MEMORANDUM

TO: BARB MC BETH
FROM: RICK MEADER, LANDSCAPE ARCHITECT
SUBJECT: PROPOSED REVISIONS TO LANDSCAPE ORDINANCE AND LANDSCAPE DESIGN MANUAL
DATE: FEBRUARY 15, 2016

AN ORDINANCE TO AMEND THE CITY OF NOVI CODE OF ORDINANCES, ORDINANCE 14-271, THE CITY OF NOVI ZONING ORDINANCE, AS AMENDED AT ARTICLE 5.0, "SITE STANDARDS," SECTION 5.5, "LANDSCAPE STANDARDS: OBSCURING EARTH BERMS AND WALLS, RIGHTS-OF-WAY BUFFERS, AND INTERIOR AND EXTERIOR LANDSCAPE PLANTINGS" IN ORDER TO COMPREHENSIVELY REVISE THE LANDSCAPE PLANTINGS AND BUFFERING REQUIREMENTS OF THE ZONING ORDINANCE.

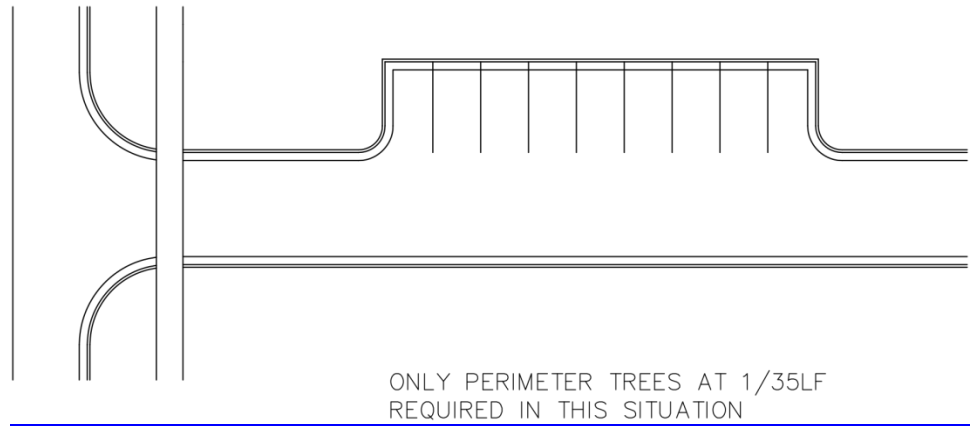
- (4)(7) If a parking bay abuts a drive but no other parking, only perimeter trees along the drive and parking are required (no interior parking). See illustration below:

ONLY PERIMETER TREES AT 1/35LF
REQUIRED IN THIS SITUATION

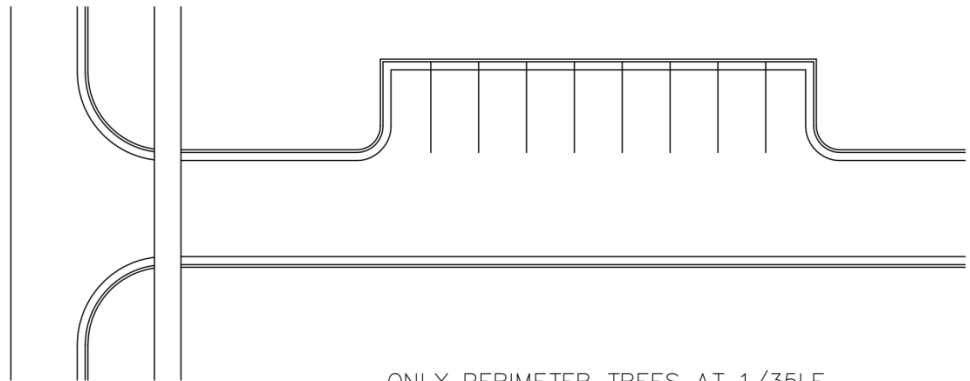
- (7) If a parking bay abuts a drive but no other parking, only perimeter trees along the drive and parking are required (no interior parking). See illustration below:
